**Proposed detail 68.6.4**  
**N. Weiner comment on 802.3aq Draft 1.0**  
**January 2005**

**68.6.4 OMA:rms noise ratio measurement - EXAMPLE 1**

**Figure 68-XX - ZERO and ONE histograms for OMA:rms noise ratio measurement**

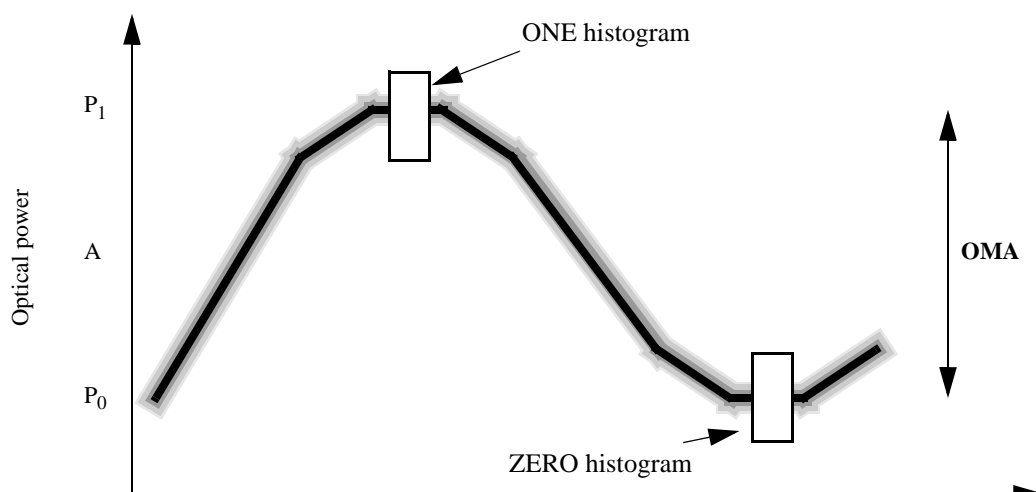
Applying the square wave test pattern specified in Table 68-5, histograms of the ONE and ZERO levels are taken, with 1 UI wide windows at the positions indicated in Figure 68-XX.

The OMA:rms noise ratio is given by:  
 :

$$\frac{\text{ONE mean} - \text{ZERO mean}}{0.5 \times (\text{ONE noise} + \text{ZERO noise})}$$

- ONE mean is the mean of the ONE histogram;
- ZERO mean is the mean of the ZERO histogram;
- ONE noise is the standard deviation of the ONE histogram;
- ZERO noise is the standard deviation of the ZERO histogram.

The bandwidth of the oscilloscope is to be approximately equal to the bit rate (i.e. 10 Gbps). The low frequency cutoff is to be less than 1 MHz.

**Figure 68-XXX Transmitter OMA:rms noise ratio measurement setup**

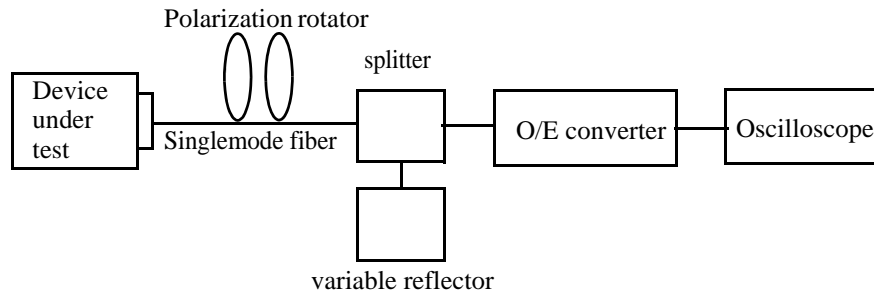
The measurement setup for transmitter OMA:rms noise ratio is given in Figure 68-XXX. The optical path and detector combination are configured for a single dominant reflection with an optical return loss specified in Table 68-3. The length of the test cable not critical, but should be in excess of 2 m. The polarization rota-

tor is required to be capable of transforming an arbitrary orientation elliptically polarized wave into a fixed orientation linearly polarized wave, and should be adjusted to maximize the noise.

Calibration of the OMA:rms noise ratio for the comprehensive stressed receiver tests is to be conducted without ISI impairment.

Figure 68-XXX Transmitter OMA:rms noise ratio measurement setup

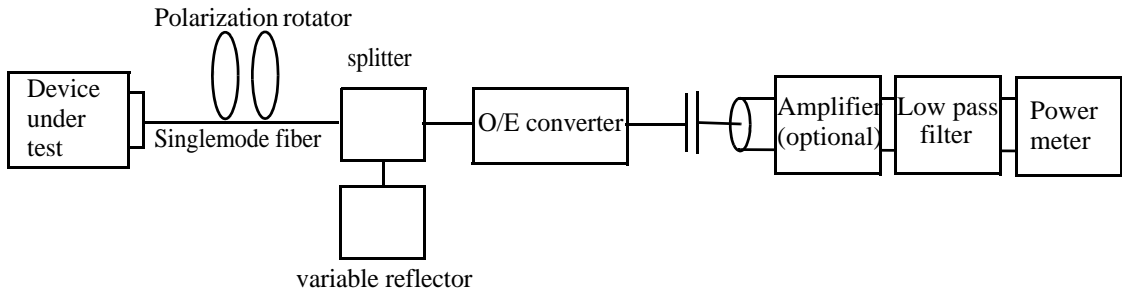
The measurement setup for the transmitter OMA:rms noise ratio measurement is shown in Figure 68-XXX.

**Optical path:** The optical path and detector combination are configured for a single dominant reflection with an optical return loss specified in Table 68-3. The length of the test cable not critical, but should be in excess of 2 m.

**Polarization rotator:** The polarization rotator is required to be capable of transforming an arbitrary orientation elliptically polarized wave into a fixed orientation linearly polarized wave, and should be adjusted to minimize the OMA:rms noise ratio.

**The O/E converter (and optional amplifier):** The O/E converter (and optional amplifier) deliver an output level appropriate for accurate measurement by the power meter.

**Filter:** The bandwidth of the measurement apparatus is to be approximately equal to the bit rate (i.e. 10 Gbps). The low frequency cutoff is to be less than 1 MHz.

**Power meter:** The RMS electrical power meter should be capable of being zeroed in the absence of input optical power, to remove any residual noise.

- a) With the DUT disconnected, zero the power meter;
- b) Connect the DUT, turn on the laser, and ensure that the laser is not modulated;
- c) Operate the polarization rotator while observing the power meter output to maximize the noise read by the power meter. Note the maximum power,  $P_N$ ;
- d) Turn on the modulation to the laser using the specified square wave pattern and note the power measurement,  $P_M$ . It may be necessary to change or remove the effective reflection to obtain an accurate reading;

OMA:rms noise ratio is given by  $(2 \times P_M)/P_N$ .
